PROJECT: EAST CHALLOW		CLIENT: CREST NICHOLSON	
DRAWING TITLE: PROPOSED DEVELOPMENT ACCESS GHOST ISLAND STAGGERED JUNCTION			
DRAWN: TL	CHECKED: PW	DATE: 12.10.17	SCALE: 1:500 @ A1

DRAWING NUMBER:
VD17541-SK16

P17/V2884/FUL – land at Park Farm, East Challow

Proposed changes to planning conditions:

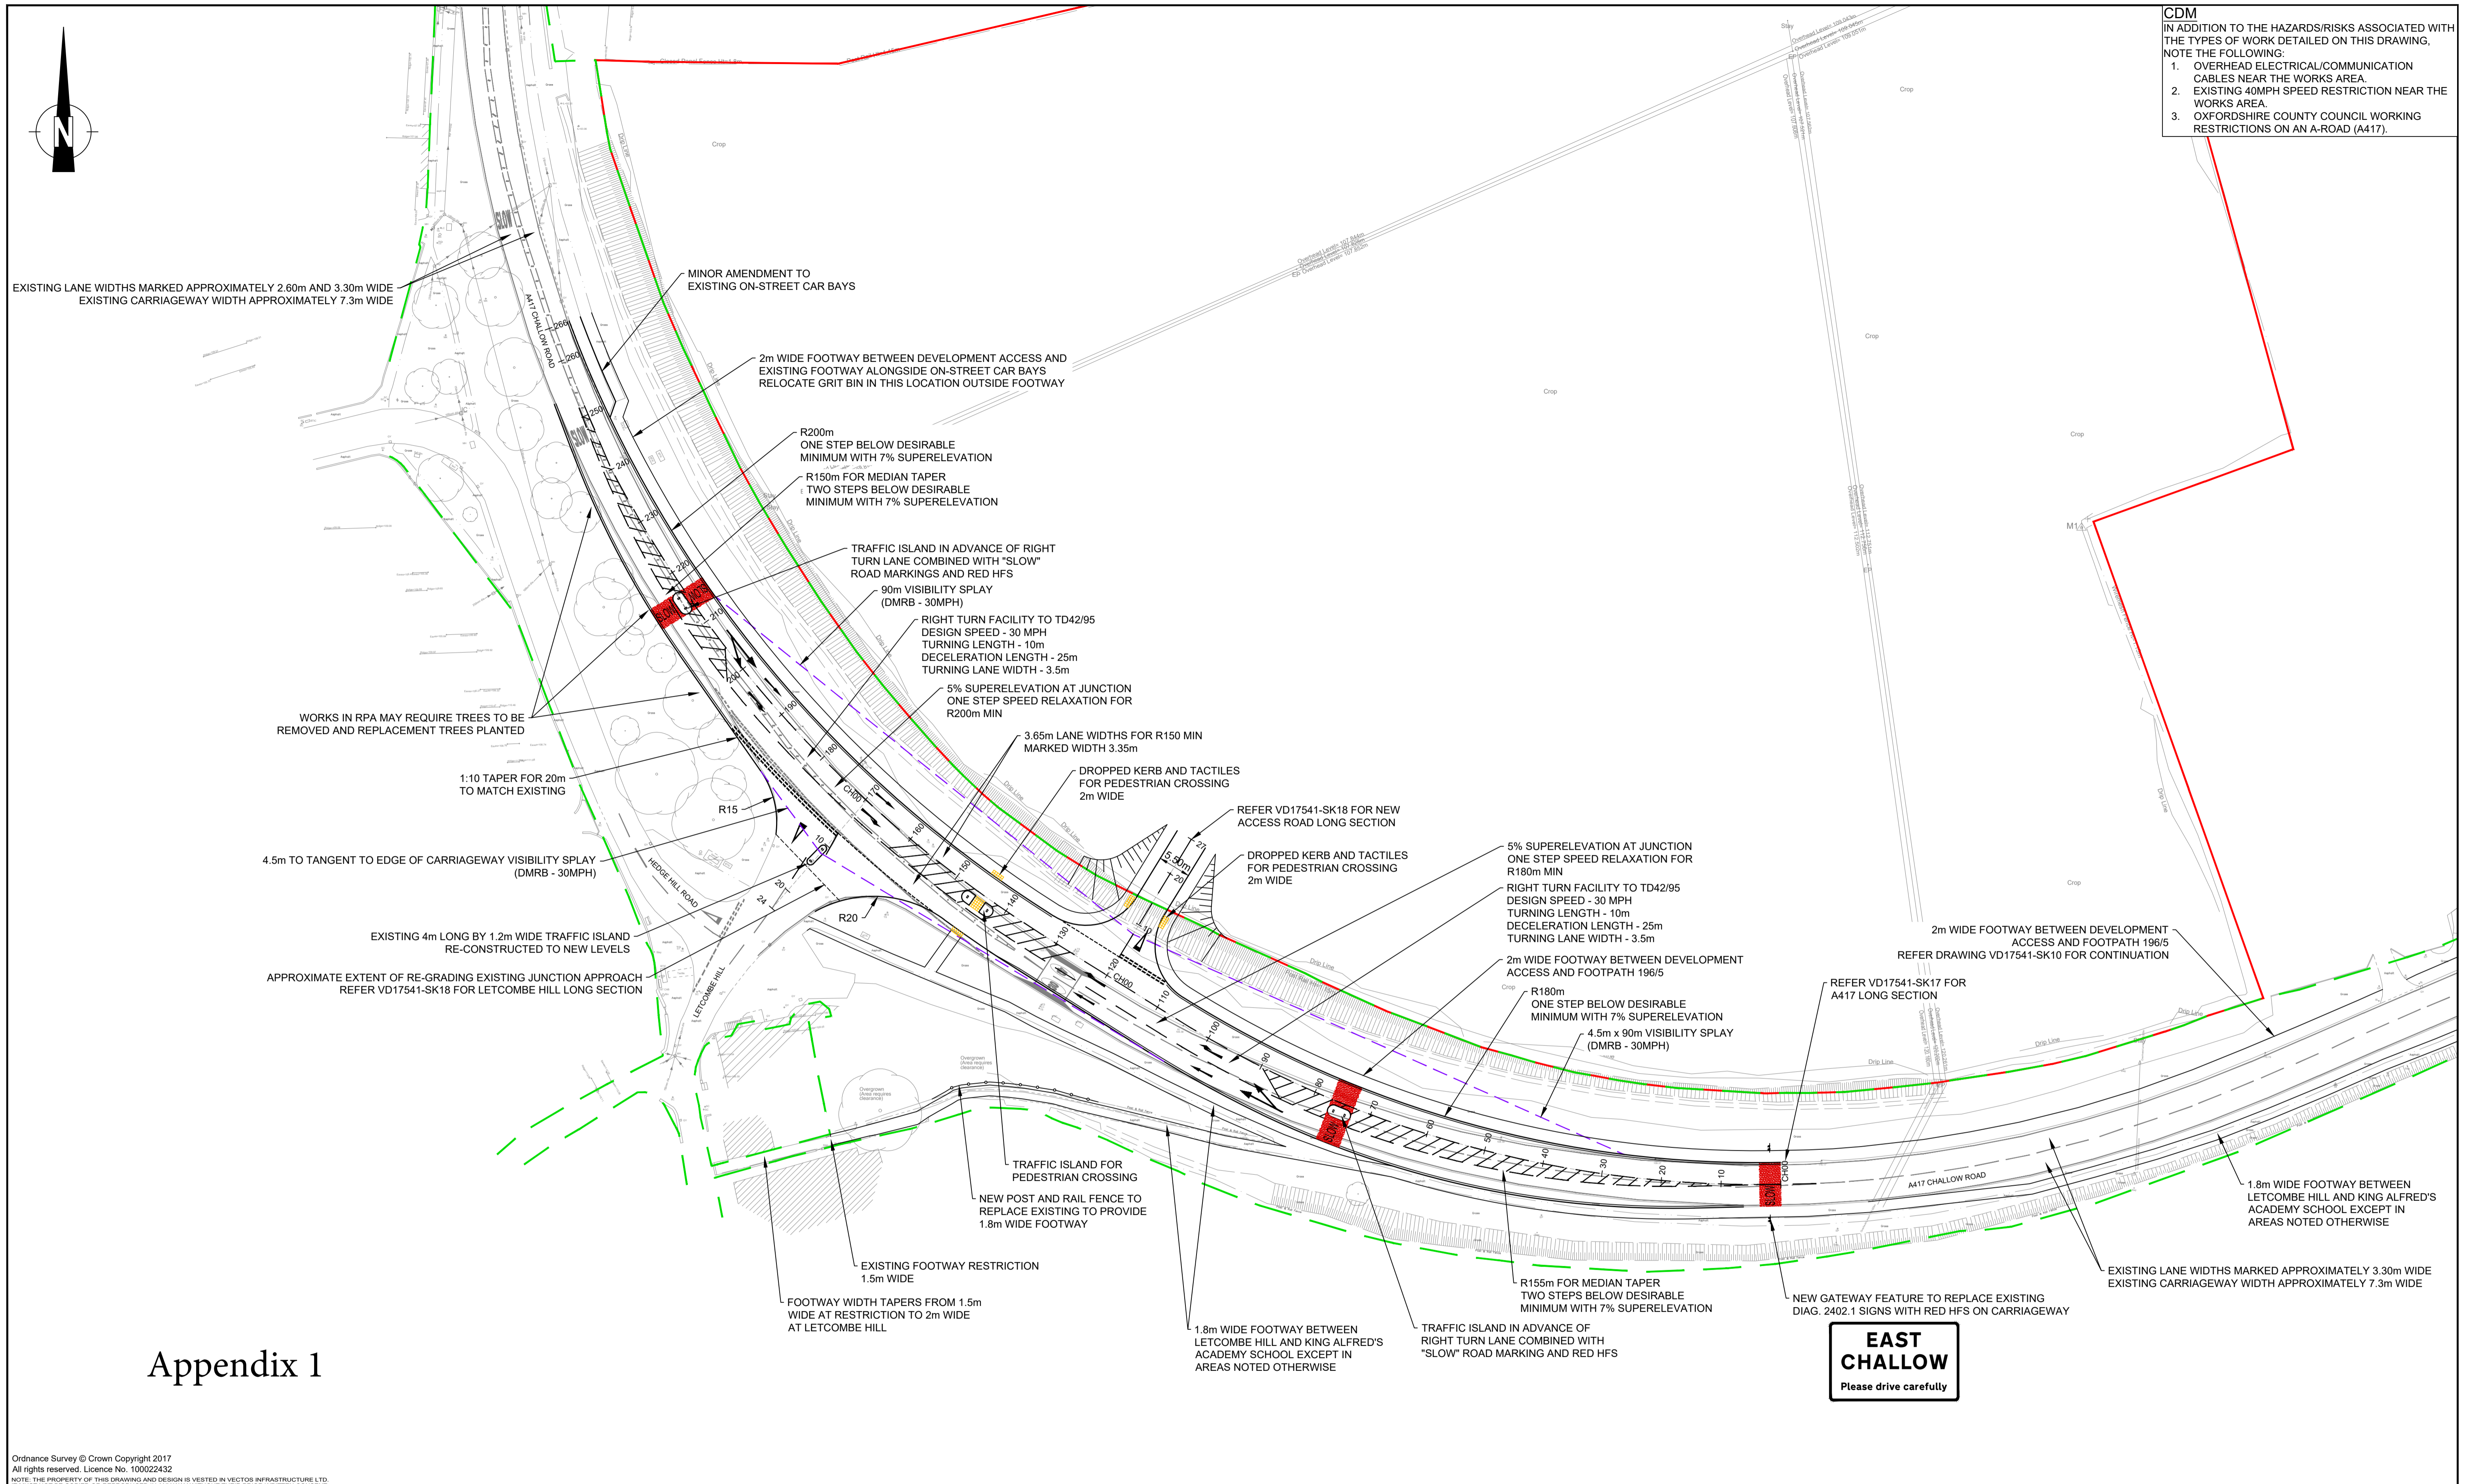
The applicant seeks to change condition 10 to read:

Prior to the first occupation of any dwelling the details of the proposed priority junction including its appearance and pedestrian crossing points as detailed in drawings VD17541-SK10-A and VD17541- SK16-A (unless agreed otherwise) shall be implemented in full.

The applicant seeks to change condition 11 to read:

Prior to the use of the priority junction, vehicular and pedestrian visibility splays shall be provided in accordance with a detailed scheme that shall first be submitted to and approved in writing by the local planning authority. Thereafter, the visibility splays shall be permanently maintained free from obstruction to vision above 900mm.
